Contract No. 24111 PP0
Project No. 300200006
Wilkens Police Precinct New Building (Leed Silver Certification) –
901 Walker Avenue, Catonsville, Maryland 21228
Catonsville – District 1c1

ADDENDUM NO. 5

DATE: 11/10/2025

Wilkens Police Precinct New Building (24111 PP0)

1 ENLARGED PLAN - LOBBY AREA
1/4" = 1'-0"

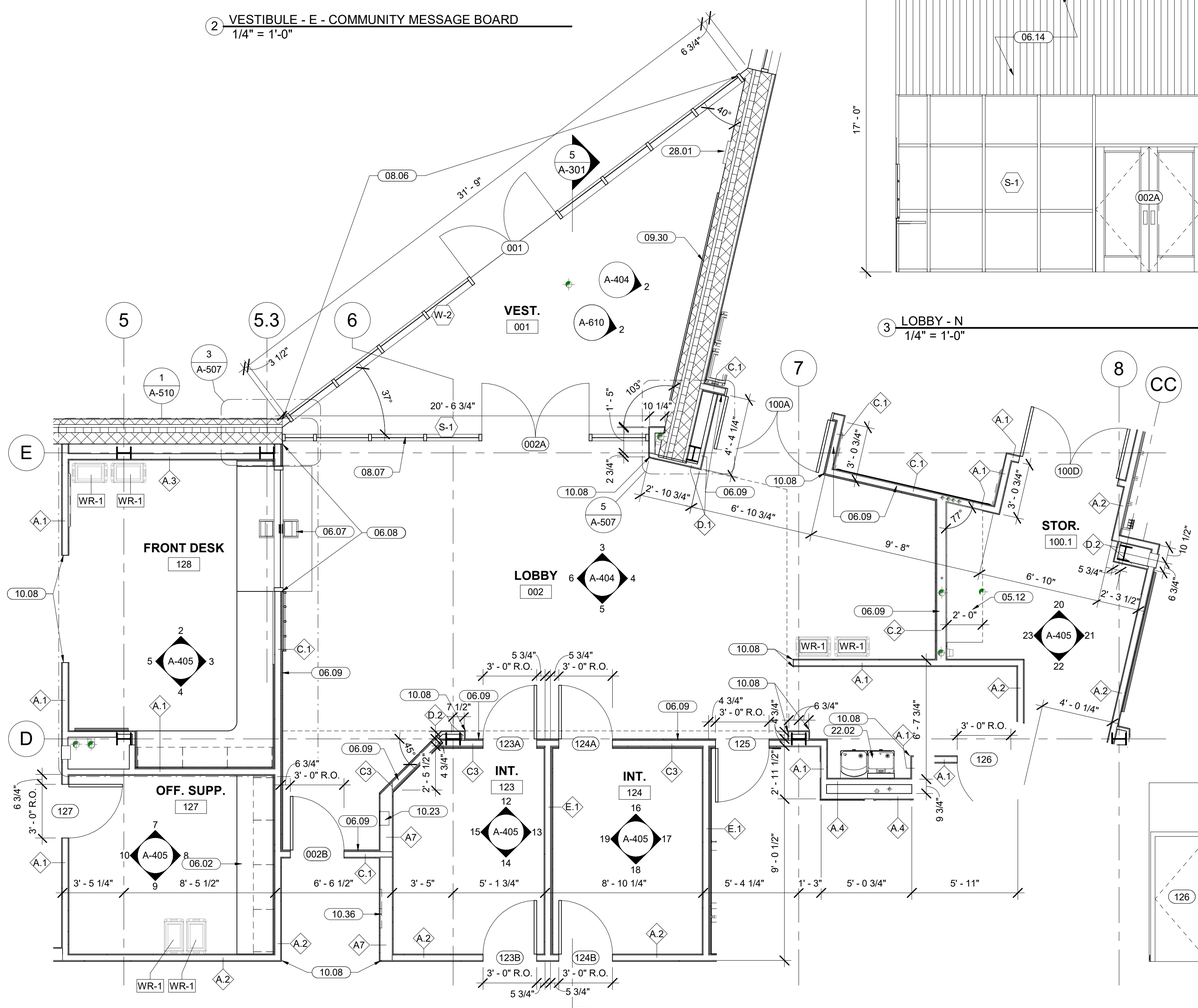
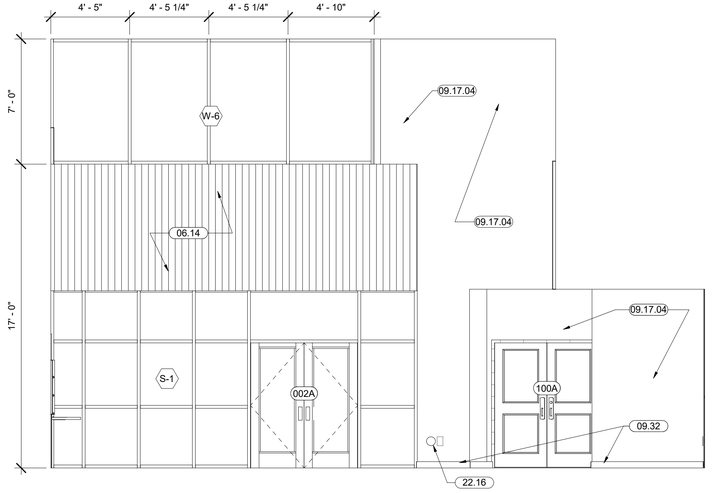
71. ***Question:*** *In Lobby East (ROOM 2), elevation 4/A-404, AWP3 is listed on the finish schedule but AWP2 is listed on the enlarged plans and elevation. Please clarify.*
Response: *These are specified as AWP-1 with FB-1-4 (fabrics). See attached revised sheets A-404 and A-600 with changes notes to AWP-1.*
